**Road vehicles — Interchange of digital
information on electrical connections
between towing and towed vehicles —**

**Application layer for brakes and running
gear**

AMENDMENT 1

Amendment 1 to ISO 11992-2:2003 was prepared by Technical Committee ISO/TC 22, *Road vehicles*, Subcommittee SC 3, *Electrical and electronic equipment*.

Figure 11 — Vehicle dimensions

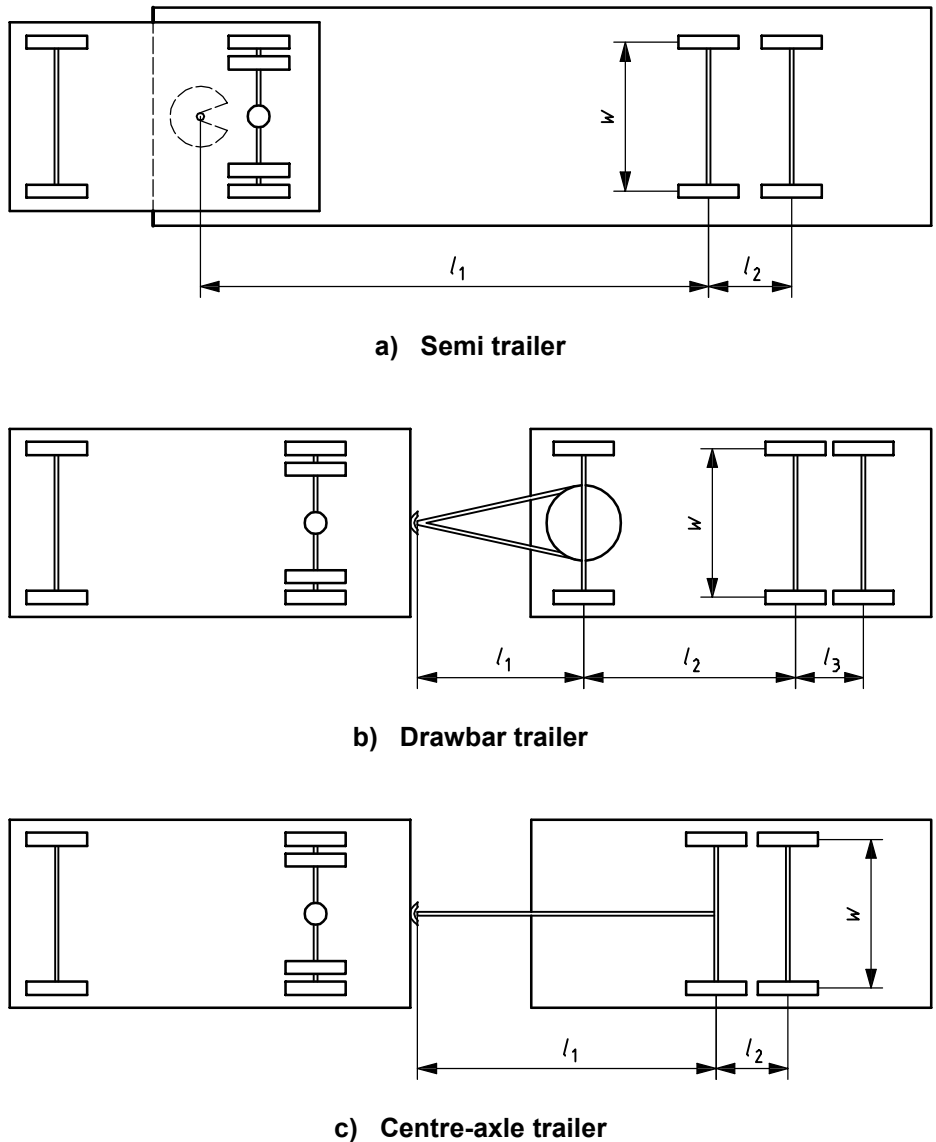
Insert the following new subclauses immediately after 6.4.2.2.40, including the new Table 7 and the new Figure 11.

- w track width
- l_1 length between coupling point and middle of the first axle
- l_2 distance between first axle and second axle in wheel base
- l_3 distance between second axle and third axle in wheel base
